IN THE DRAWINGS

REMARKS

FIG. 14

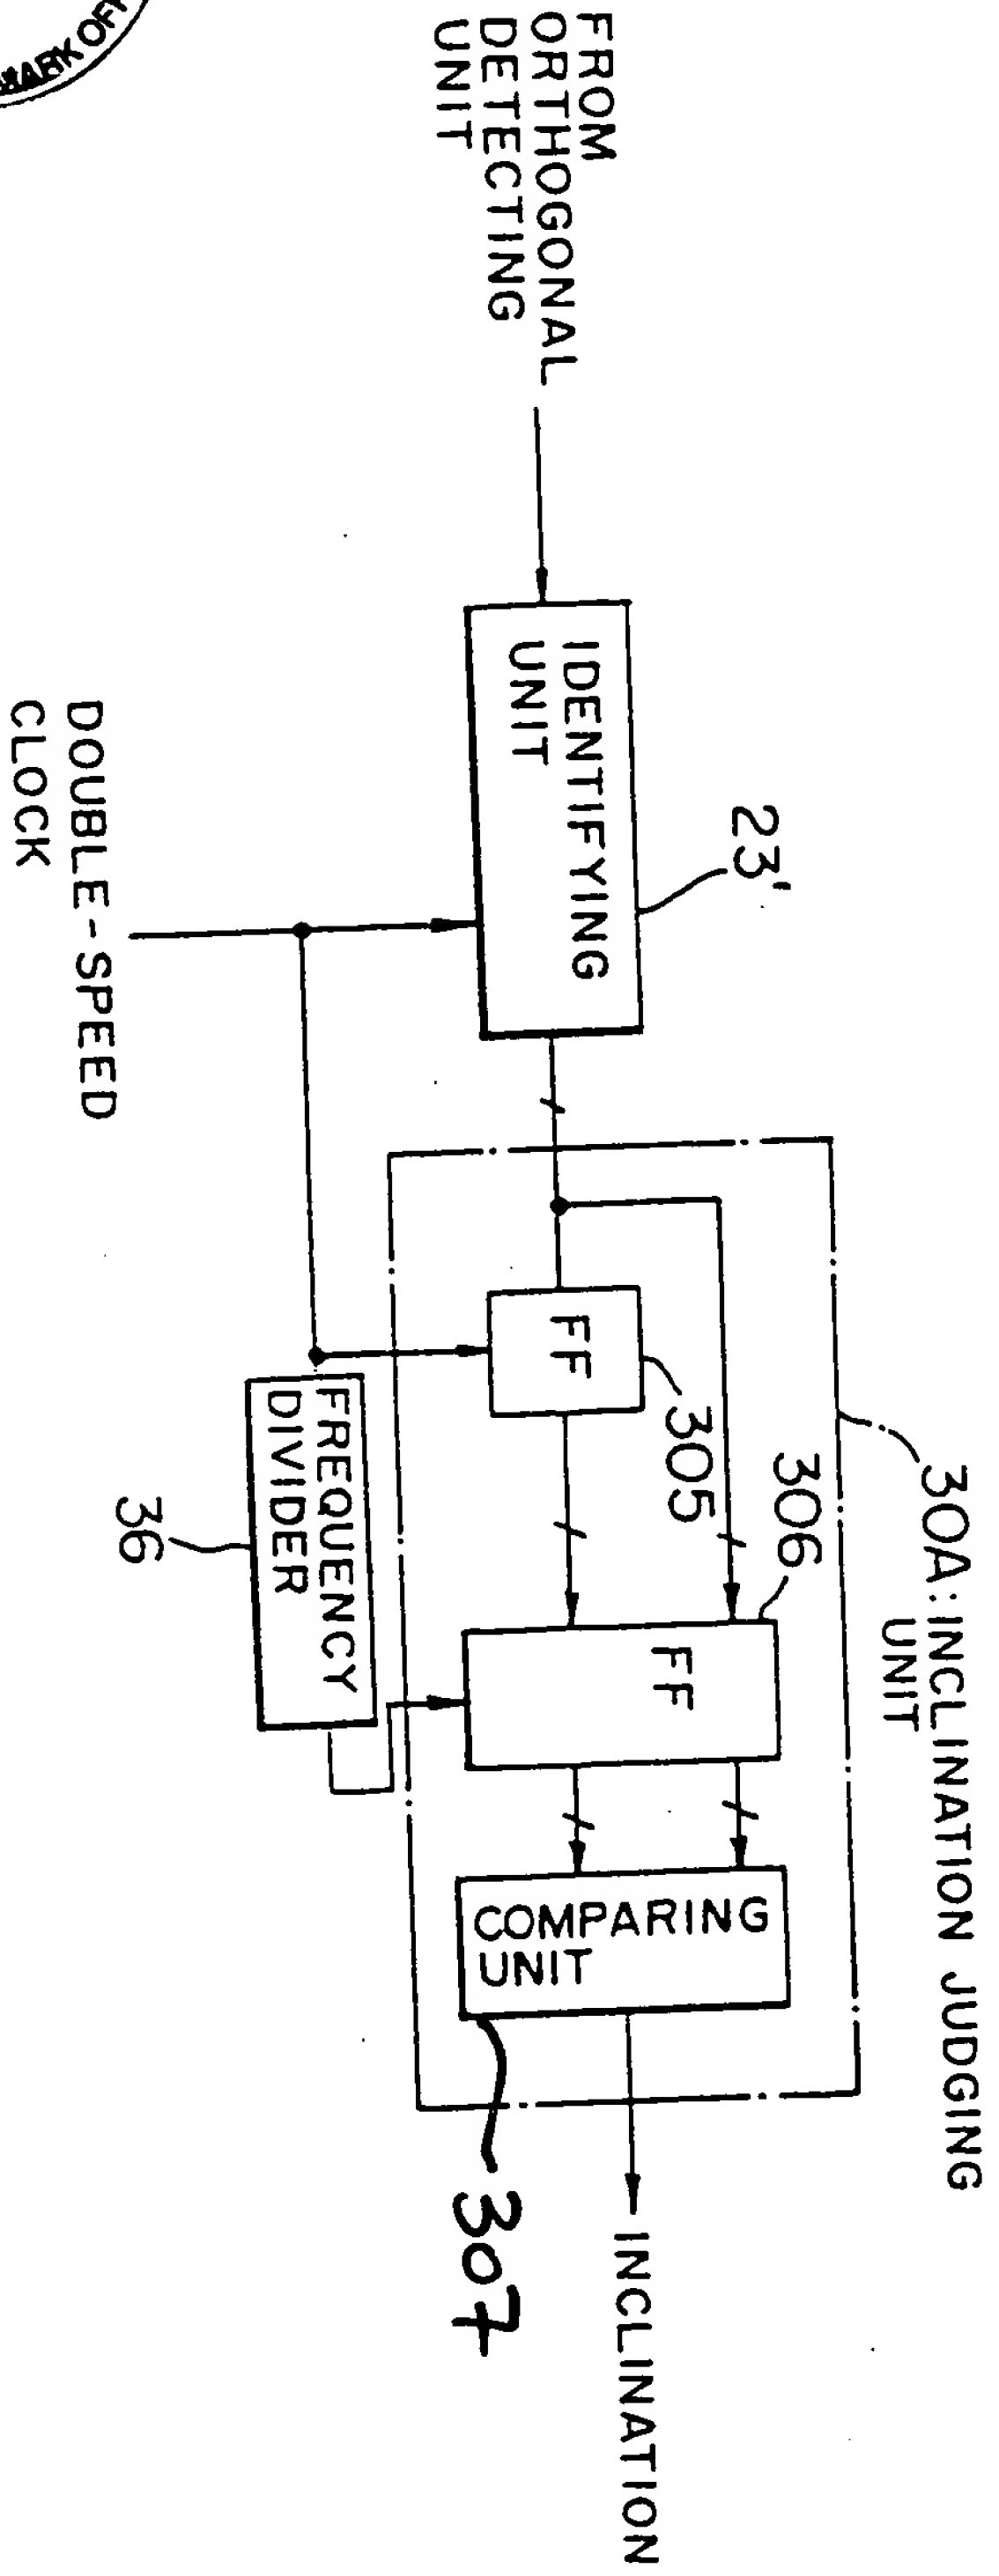
Applicants enclose an “Annotated Mark-up Drawings” and a “Replacement Sheet” for Fig. 14, adding reference numeral 307 to be consistent with the disclosure in the specification.

Amended
